POWER PLANT - ENGINE - INCORPORATE REVISED EEC FAN HARNESS CLIPPING REQUIREMENTS  
(REFERENCE CP1013) - CATEGORY CODE 3 - MOD.ENG-71-0049

V2500-ENG-71-0049

Location of the Clipping Point CP1013  
Fig.1

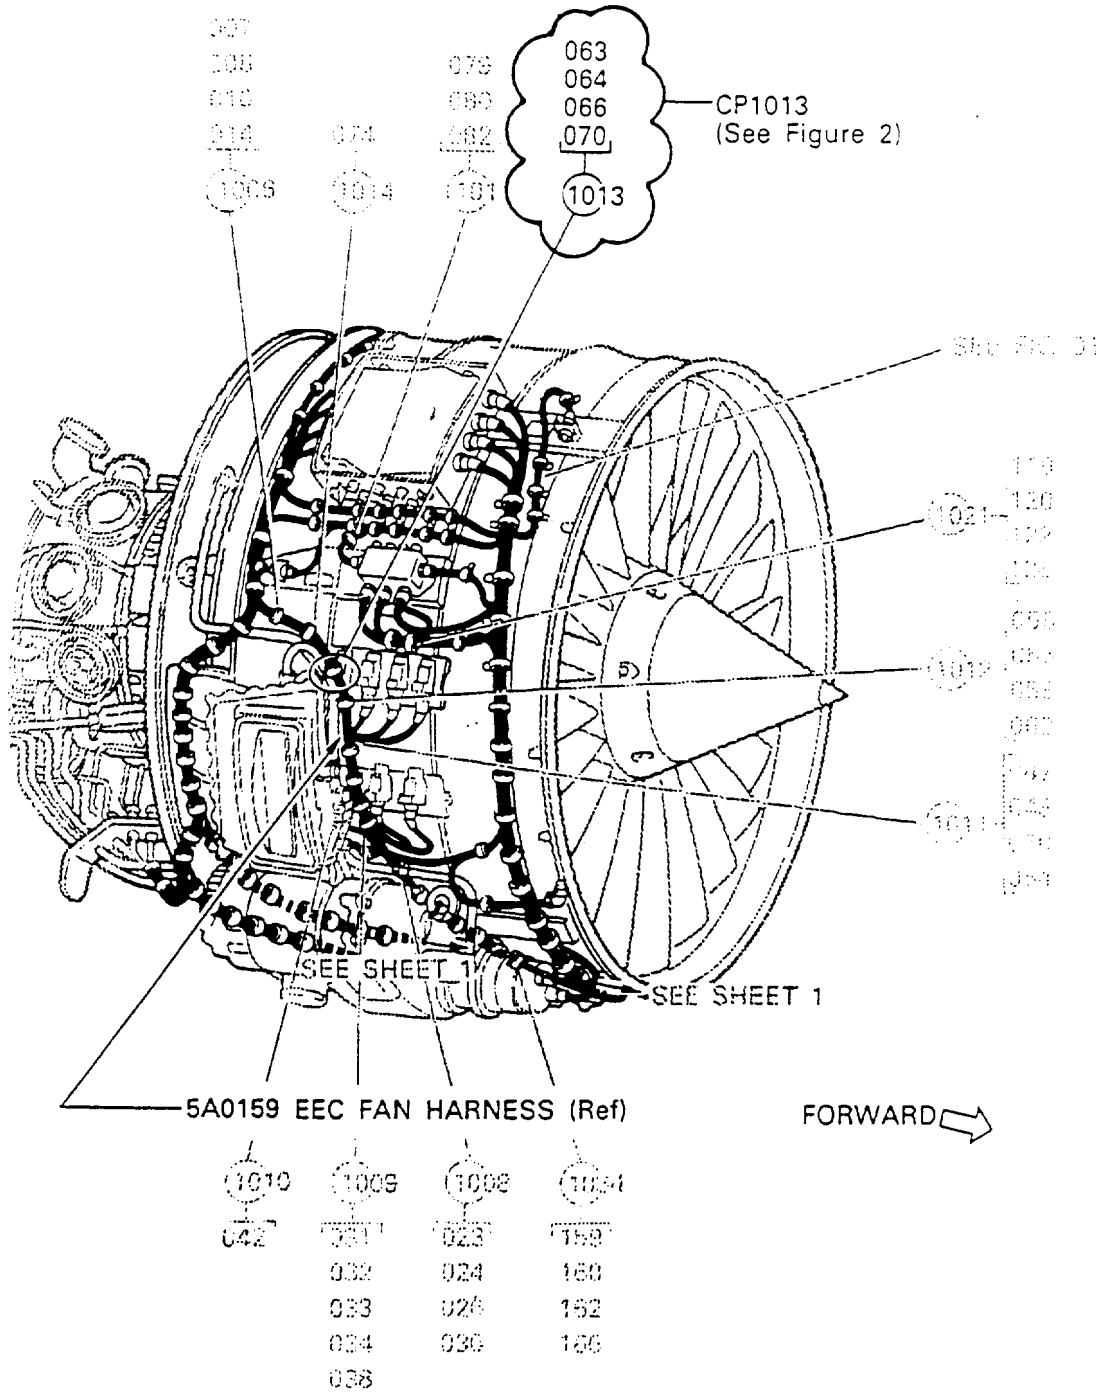
Insufficient clearance may occur between the EEC Fan Harness and the Stage 10 Bleed Solenoid Valve because of unsatisfactory clipping configuration at CP1013.

- (1) The changes introduced by this Bulletin are as follows:
- (a) The existing CP1013 which safeties the EEC Fan Harness and the Scavenge Oil Tube has been deleted to replace with CP1092, see Fig.1 and 2.
  - (b) A new CP1092 is introduced adjacent to the existing CP1013 to reroute the EEC Fan Harness, see Fig.3.
  - (c) One of the six lugs on the Scavenge Oil Tube which is used at CP1013 has been removed, see Fig.4.
- (2) The existing Scavenge Oil Tube can be reworked to a new configuration, see Fig.4.
- (3) New Scavenge Oil Tube will be available for replacement purpose.

Procedure	Supplementary Information
(1) Find the CP1013 where is the left side of the Stage 10 Bleed Solenoid Valve	Refer to Fig.1 and 2
(2) At CP1013, remove 4W0001, Nut, 4W0103, Bolt, 5W1086, Washer and JM44LC39H109RG, Clip, from 5A0159, EEC Fan Harness, and 5A9088, Scavenge Oil Tube	Refer to Fig.2

Rework of the Scavenge Oil Tube  
Fig.4, Sheet 2 of 2

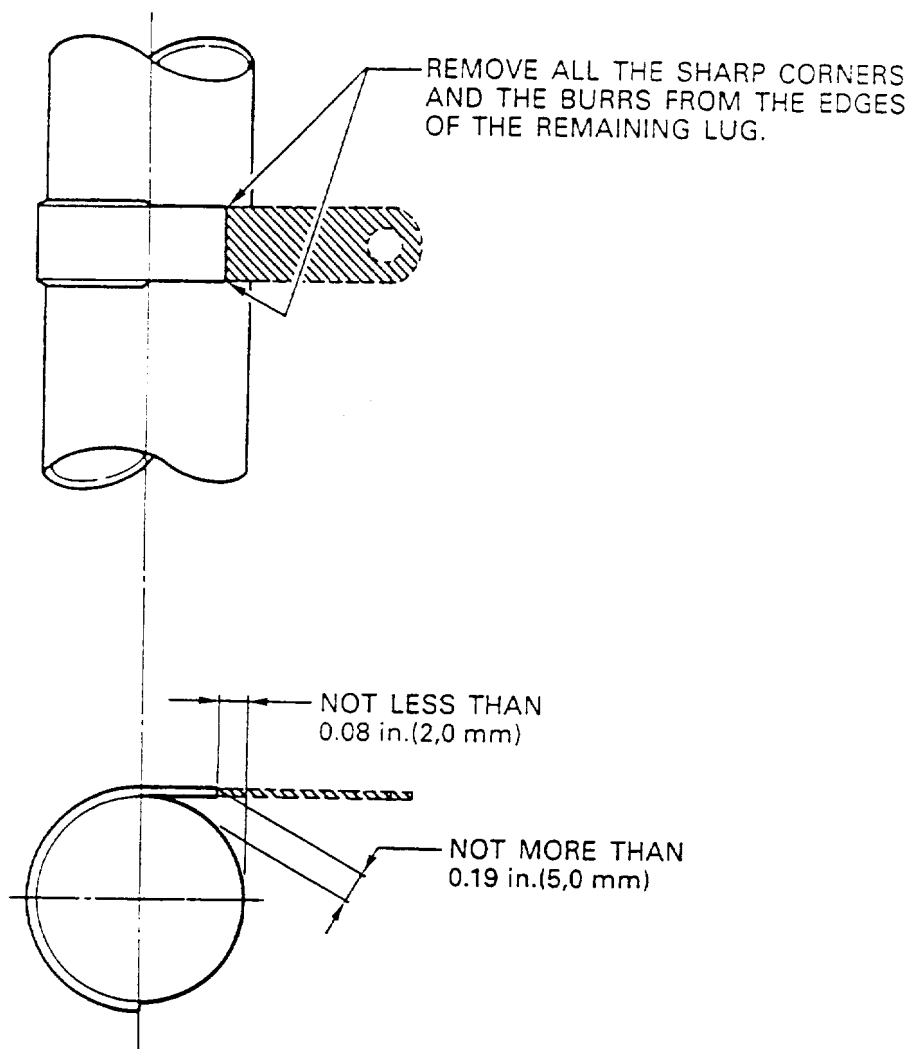
(4) Use the hand held pneumatic grinder to cut off the Lug on 5A9088, Scavenge Oil Tube	Refer to Fig.4 and 5, and the Facilities Equipment Manual, Repair Equipment specification, Indentation No.RB010 for the Pneumatic Grinder. Refer to the following suppliers for the rotary cutters:  Power tools Ltd, 13, Henley Street, Camp Hill, Birmingham, B11 1JD, ENGLAND

- (5) Remove all the sharp corners and the burrs from the edges of the remaining lug with a file

Refer to Fig.4, Sheet 2 and the Facilities Planning Manual, Mechanic's Tool-box Profile, Recommended Toolbox Content (A1 Level)
